RESPONSE TO NRC QUESTIONS

Responses to NRC Questions  
San Onofre 2&3

Figure 032.39-1

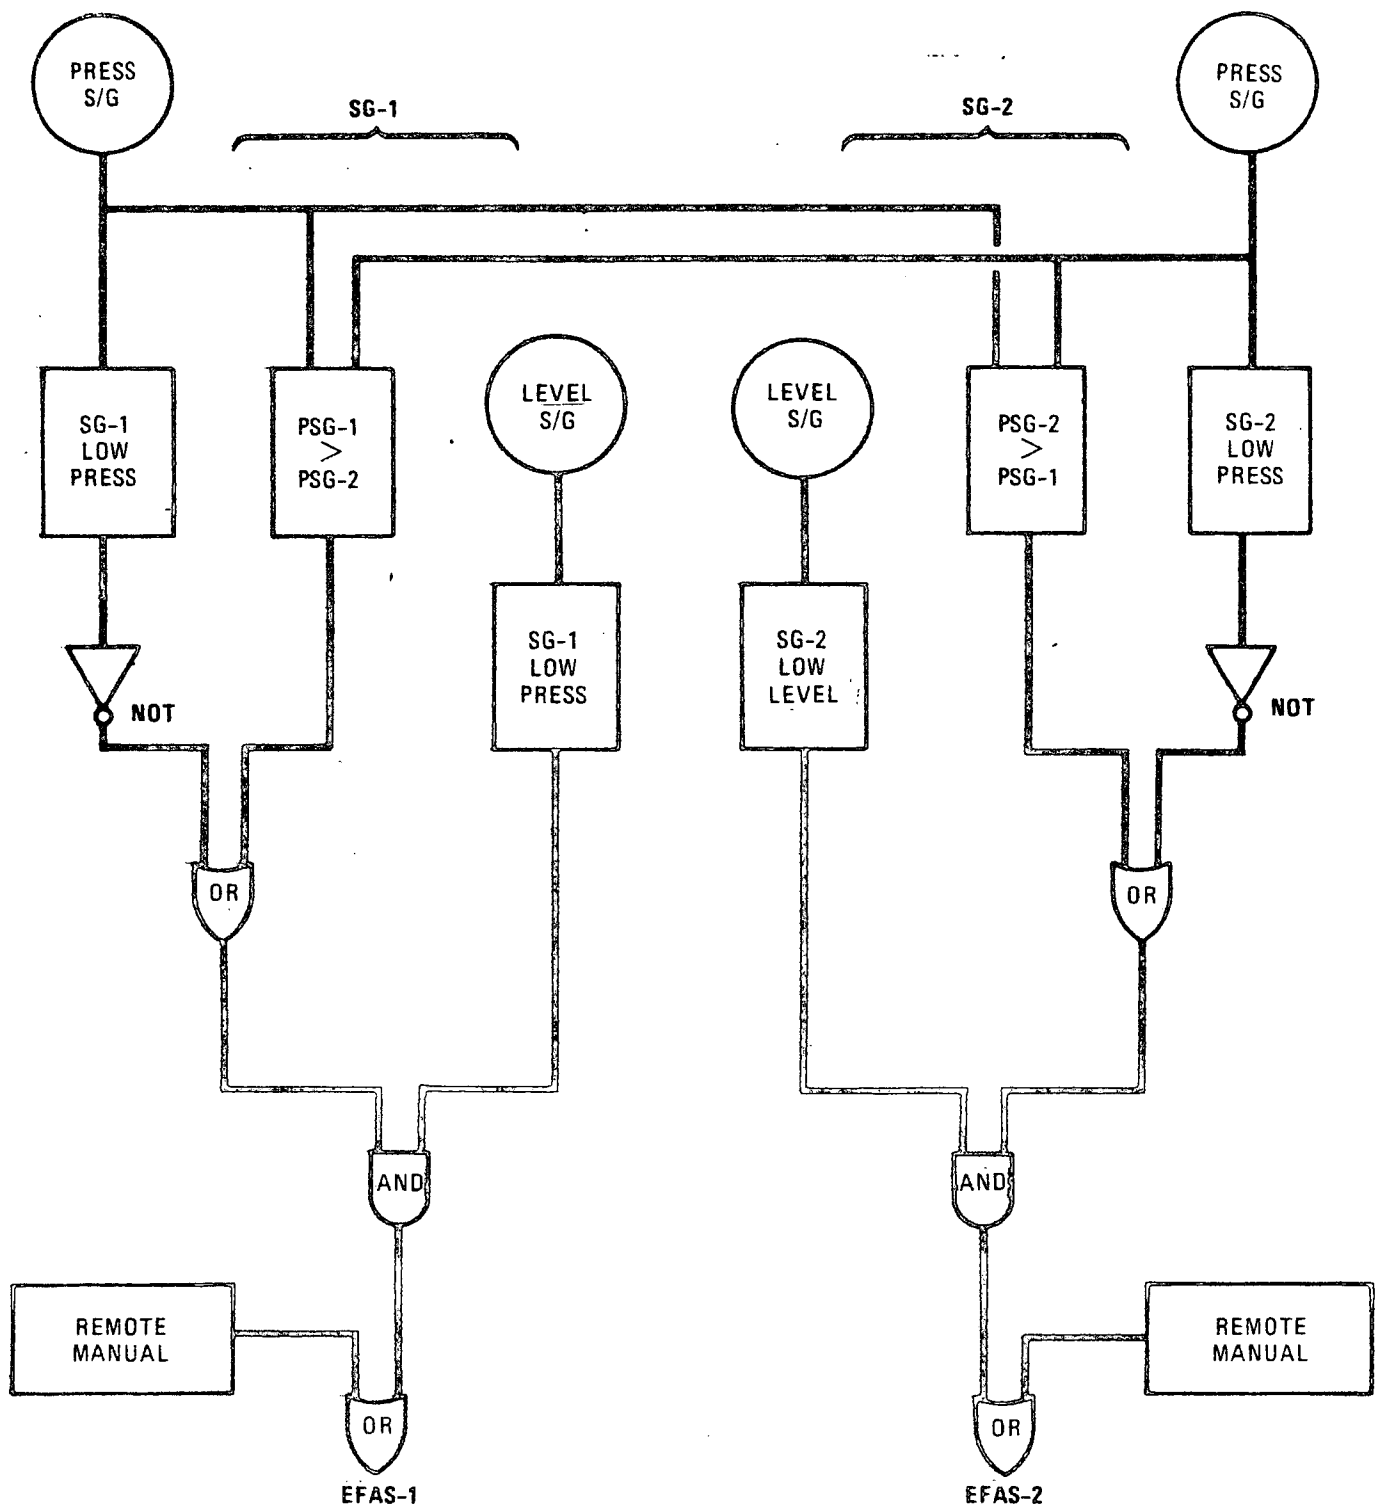
Section 7.3.1 of the FSAR states that the discharge valves of the emergency feedwater system are automatically closed to secure excess feedwater flow when the steam generator water level returns above the low level set point. Provide a detailed description of the operation of these valves, including logic and electrical schematic diagrams. Identify all valves involved in this operation.

The San Onofre Units 2 and 3 emergency feedwater actuation signal (EFAS) automatically actuates the auxiliary feedwater system by fully opening the isolation and control valves to deliver a minimum feedwater flowrate of 700 gal/min to the intact steam generator(s). The EFAS is initiated for the intact steam generator either by a low steam generator level coincident with no low pressure trip present on the intact unit or by a low steam generator level coincident with a differential pressure between the two steam generators with the higher pressure in the intact unit.

The two-out-of-four logic is provided independently for each steam generator. When steam generator water level returns to the reset point above the low level setpoint, the auxiliary feedwater system discharge valves will shut automatically as the EFAS is removed to secure excess feedwater flow. The EFAS will continue to function as required to maintain steam generator water level while the plant remains at hot standby or is brought to cold shutdown. Figure 032.39-1 shows the San Onofre Units 2 and 3 EFAS logic and FSAR figure 10.4-9 is the San Onofre Units 2 and 3 auxiliary feedwater system showing the system relationship of the valves, two motor-driven pumps and the turbine driven pump.

The third pump (motor-driven) has recently been added to the system to improve reliability resulting in a redesign of the piping system (FSAR subsection 10.4.9). The EFAS logic was not changed by this action. Subsection 7.3.1 changes to reflect the three pump system will be provided by January, 1980.
